ADDENDUM NO. 2

SARATOGA LIBRARY SOLAR PROJECT

March 27, 2012

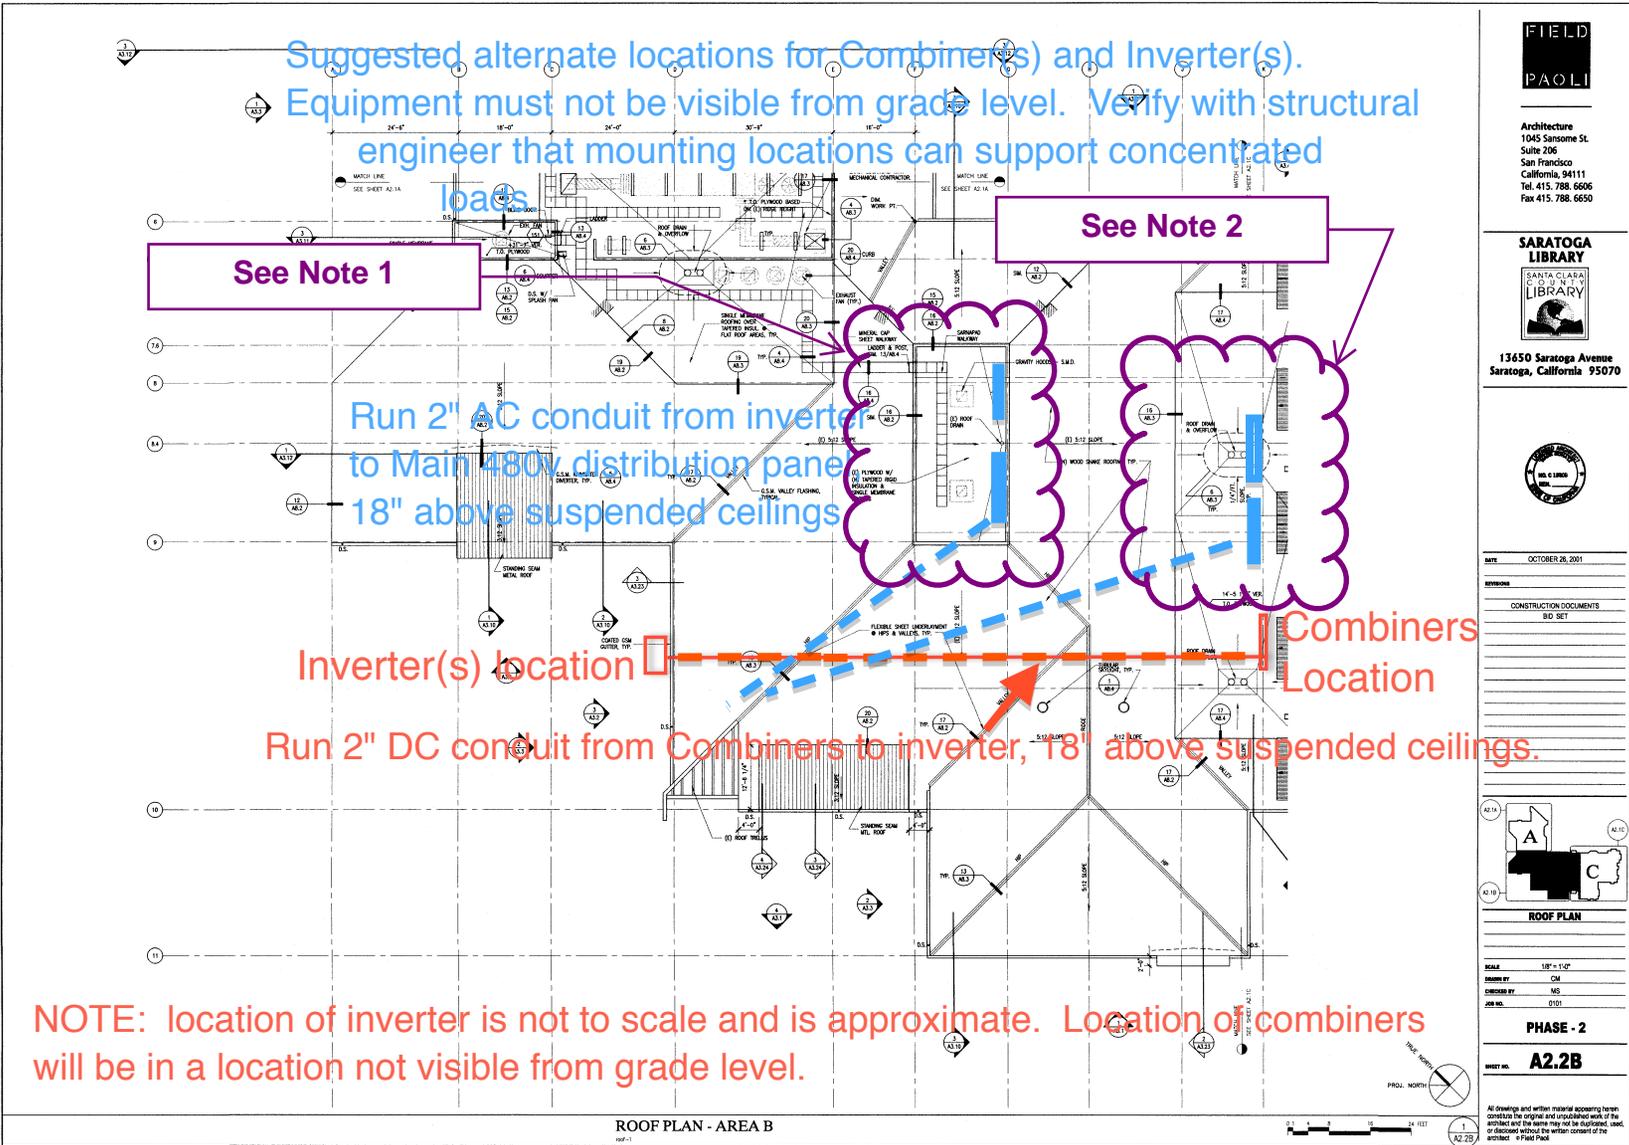
Alternate location of Inverters/Combiners:

Attached is a schematic drawing showing alternate location for Combiner(s) and Inverter(s) and notes regarding the structural support of the equipment. The equipment, if proposed on the roof, must not be visible from the ground level.

1. Without dimensional and weight information of proposed equipment, it is not possible to confirm structural adequacy. Existing framing is unclear in this region. Arch. drawings imply 2x14's at 16" o.c. in this region.

2. Existing 14" TJI framing in this region. Framing likely adequate to support light- to medium-weight equipment. Direct lag drilling into TJI's is not acceptable. Additional structural blocking will be required between TJI joists for equip anchor lag screw attachments.

Contractor to verify existing framing. If confirmed, then 2x14 @ 16" is likely adequate to support and anchor light-to medium-weight equipment.
